Meeting: Traffic Management Meeting

Date: 21 November 2013

Subject: Hitchin Road and Clifton Road, Shefford

Summary: This report seeks the approval of the Executive Member for Sustainable

Appendix A – Drawings of Proposed Raised Zebra Crossing and No Waiting

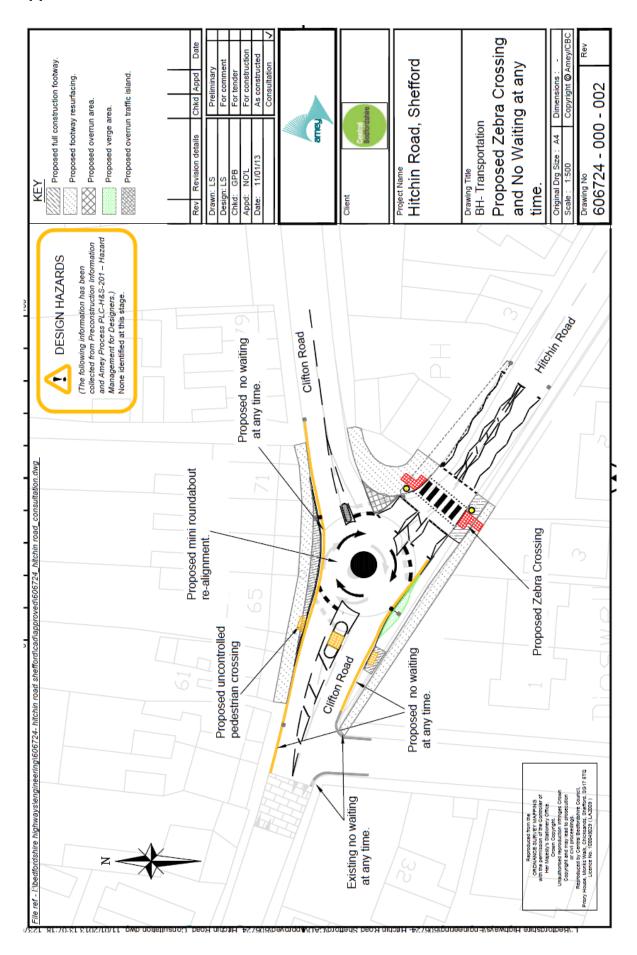
- 7. The main points raised by the objectors relate to the proposed waiting restrictions on Clifton Road and are as follows:
 - a) The cottages on the north side of Clifton Road have no off-road parking and the uncontrolled crossing point and yellow lines would prohibit parking outside their homes.

- Various issues relating to the design of the mini-roundabout, such as the removal of trees, manoeuvring space for larger vehicles, will not reduce speeds or improve safety.

- b) Parking restrictions should also be considered on the south side of Clifton Road.
 - c) The location of the zebra crossing in relation to the mini-roundabout.

The actual positioning of the Zebra crossing and its amber flashing lights on your diagram. From your diagram of the proposed layout of the Zebra crossing, we have assumed the beacon on our side of the road with be placed so that the high wall separating us with 2 Hitchin Road will shadow the light emitted from it. If this is not the case then we would certainly not want amber flashing lights, lighting up our front windows.

On the diagram we noticed an area shaded green indicating grass verge, this may seem like a good idea on paper but practically this area would end up with tyre ruts from large vehicles trying to get round the roundabout. Surely a solid base area would be more practical for the over steerage of large vehicles.

Is this not too close to the junction? Surely vehicles coming down Clifton Road, to turn into Hitchin road, would not see anyone on the crossing until after they have started to go round the corner?

I notice the No waiting restriction is only on the North side of Clifton road. Should this not also be mirrored on the South side, to the same point as on the North?

- 10. Bedfordshire Highways' response to the specific points listed in 4. above are as follows:
 - a) It is accepted that there are properties on this length of Clifton Road that have no off-road parking. However, it is not ideal for parked cars to be positioned on the immediate approach to a mini-roundabout. In addition, as part of the re-design of the mini-roundabout, the footway on the north side of Clifton Road is being widened, so there is less road width at that point to accommodate on-street parking. There are concerns that the parked cars encourage passing traffic to move towards the centre of the road and consequently take a straight line through the junction, particularly when heading towards Hitchin Road.

- 12. Bedfordshire Highways' response to the specific points listed in 5. above are as follows:
 - a) The proposed re-alignment of the mini roundabout is designed to increase vehicle entry deflection, which should help to reduce approach speeds. All approaches were modified to improve visibility, especially on the westbound carriageway of Clifton Road heading towards the town centre. Auto track software has been used to predict vehicle paths and this has been incorporated into the detailed design. Traffic information and accident data were checked and considered in the design. The scheme will include the removal of vegetation (subject to ecological survey) to avoid the belisha beacons being obscured.

- c) The zebra crossing was designed to be sited as close as possible to the desirable pedestrian crossing line and complies with all relevant design guidance. If the crossing was located further away, such that pedestrians had to deviant from their walking route, then it is likely that they would simply not use it.
